**BEFORE THE PUBLIC UTILITIES COMMISSION OF THE
STATE OF CALIFORNIA**

Rulemaking 20-05-003
(Filed May 7, 2020)

**COMMENTS OF THE CALIFORNIA INDEPENDENT
SYSTEM OPERATOR CORPORATION**

Dated: October 23, 2020

Figure 1: Comparison of Incremental Capacity by Portfolio

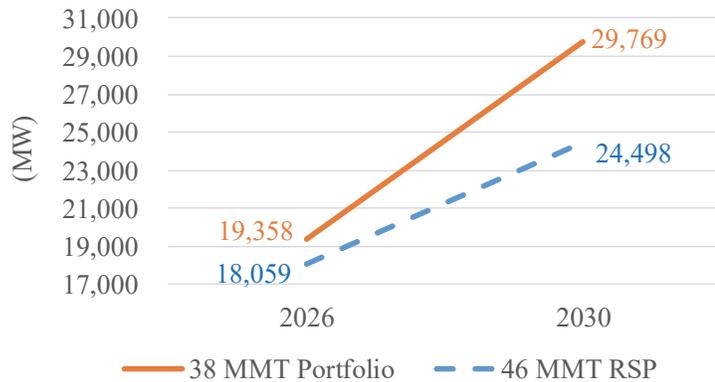
Portfolio added a net 10,411 MW¹⁰ of installed capacity between 2026 and 2030 compared with only 6,439 MW under the 46 MMT RSP. The 38 MMT Portfolio also includes more incremental renewable resources but slightly less storage capacity in 2026 and 2030 than the 46 MMT RSP, as shown in Figure 1 below.

As a result, the CAISO expects that its production cost modeling would show comparable or an even greater LOLE for the RSP compared to the 38 MMT Portfolio. Energy Division staff’s SERVM production cost modeling did not show significant resource deficiencies in 2026 or 2030

Figure 2: Comparison of IEPR Load Forecasts

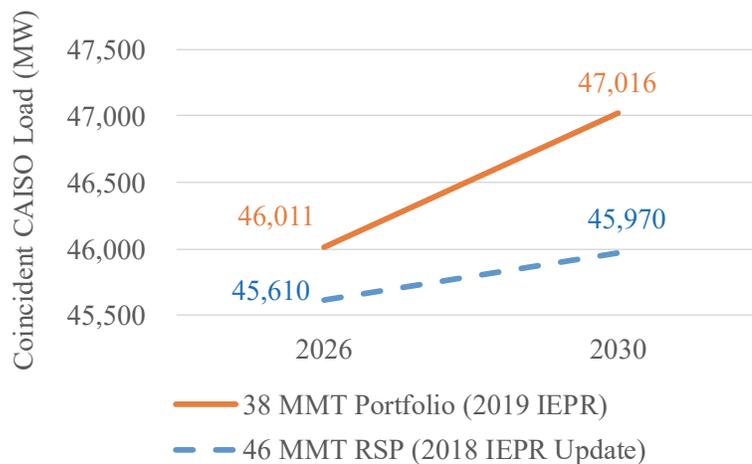
Load forecasts, on the other hand, only increased by 401 MW in 2026 and 1,046 MW in 2030 between the 2018 IEPR Update and the 2019 IEPR, as shown in Figure 2.

with the RSP. Without further extensive benchmarking, it is difficult to precisely account for why the SERVVM results differ markedly from the CAISO's production cost modeling, but the 401 MW increase in the 2026 demand forecast does not fully explain the divergence in LOLEs.
